MIL-M-28787/233B(SH)
AMENDMENT 2
30 March 1992
SUPERSEDING
AMENDMENT 1
19 November 1990

MODULES, STANDARD ELECTRONIC

AMPLIFIER, CLIPPER, ANALOG, KEY CODE FBE

FIGURE 20. Crosstalk check test circuit for table XV.

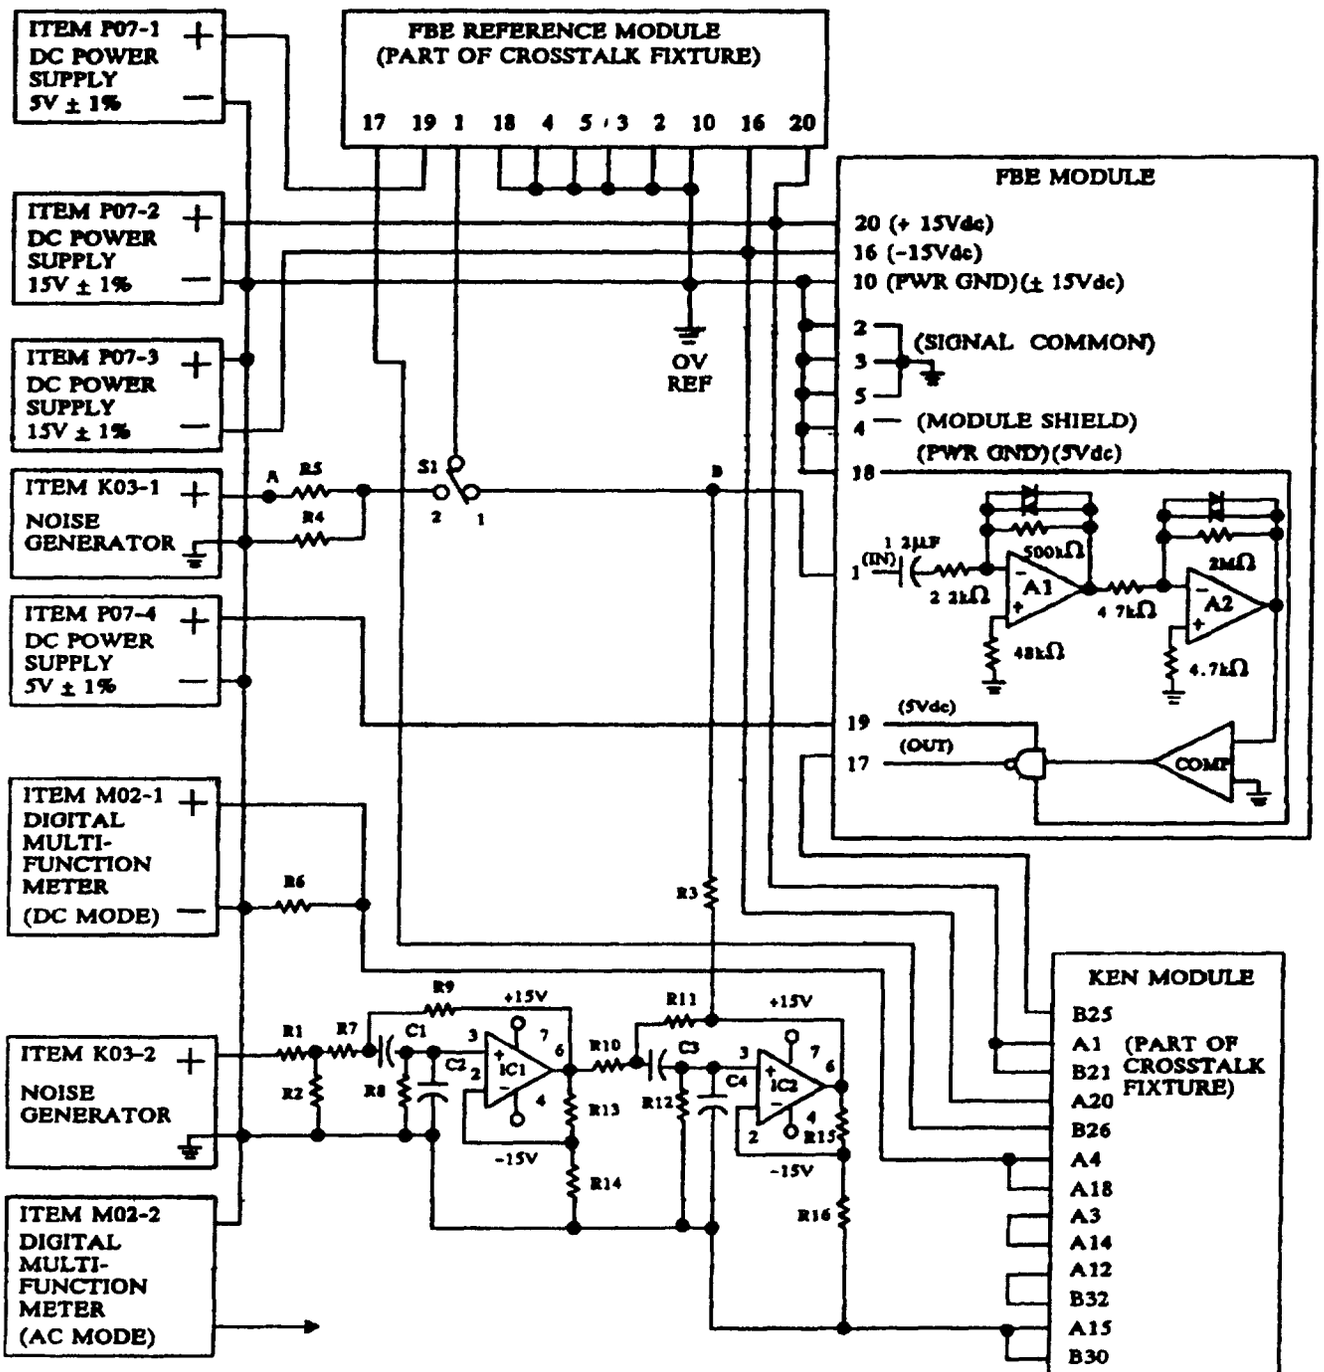
FIGURE 20: Delete and substitute new figure 20 as printed on page 4 of this amendment.
